RE: Lake View Geothermal Project (Unit 17) (79-AFC-01C): Revised Petition for Modification—Fire System Recommissioning Activities

**Lake View Geothermal Power Plant
(79-AFC-01C)**

**Revised Petition for Modification
Fire System Recommissioning Activities**

LAKE VIEW GEOTHERMAL POWER PLANT (“UNIT 17”)

Figure 2
Flow Diagram Showing Emergency Standby Wet Down Pump Diesel Drive Engine
Perkins Model 1206F-E70TTA

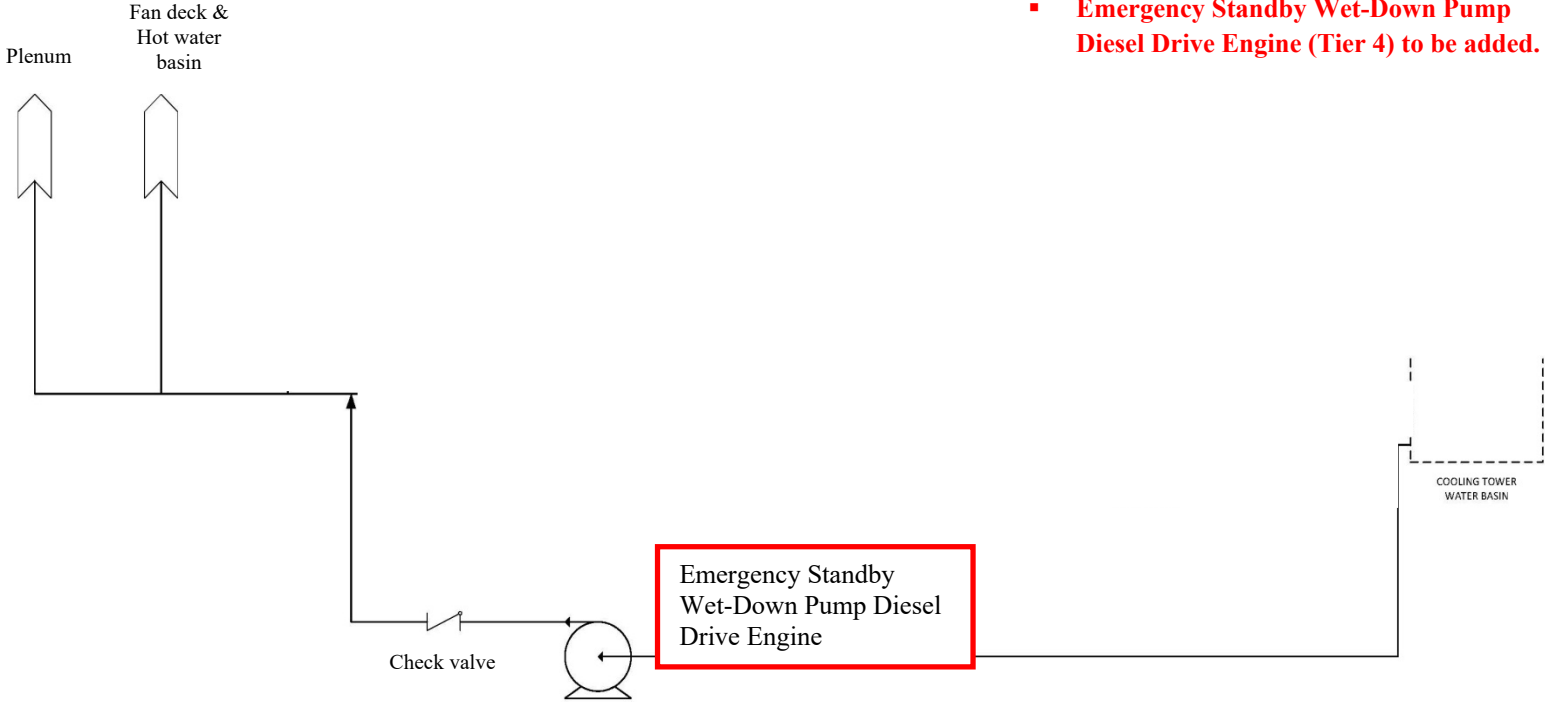
The cooling tower is proposed to be constructed with a wet down system installed to wet areas where sulfur may be found, including spray coverage in the non-wetted areas such as the fan deck, hot water basin, and plenum areas for increased protection from wild land fire embers. Figure 1 shows a Google Earth view of the location of the power plant and Figure 2 illustrates the proposed flow diagram.

Note:
▪ **Emergency Standby Wet-Down Pump Diesel Drive Engine (Tier 4) to be added.**

Figure 3
Lake View Power Plant Plot Plan Showing the Emergency Standby Wet-Down Pump Diesel Drive Engine Location

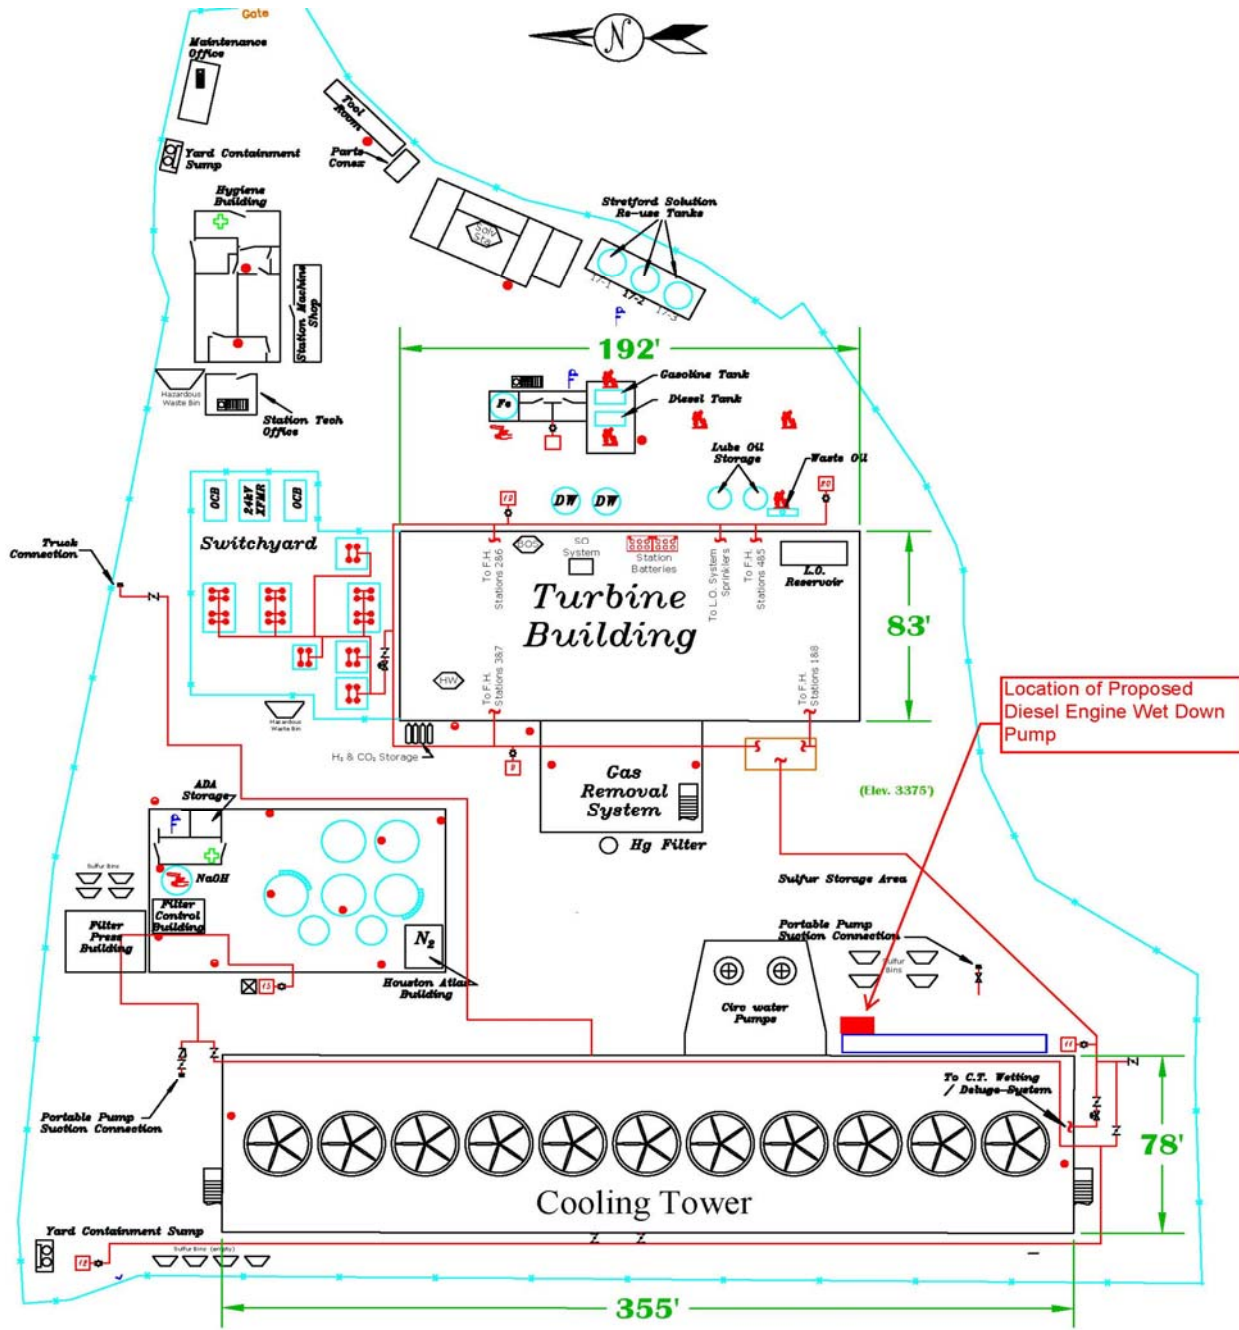
A permanent emergency standby wet down pump diesel drive engine is proposed to be added for use in the event of a plant evacuation due to the threat of an approaching wild land fire. The location of the emergency standby wet down pump diesel drive engine is shown adjacent to the cooling tower circulating water pit on the Lake View Power Plant Plot Plan (**Figure 3**).
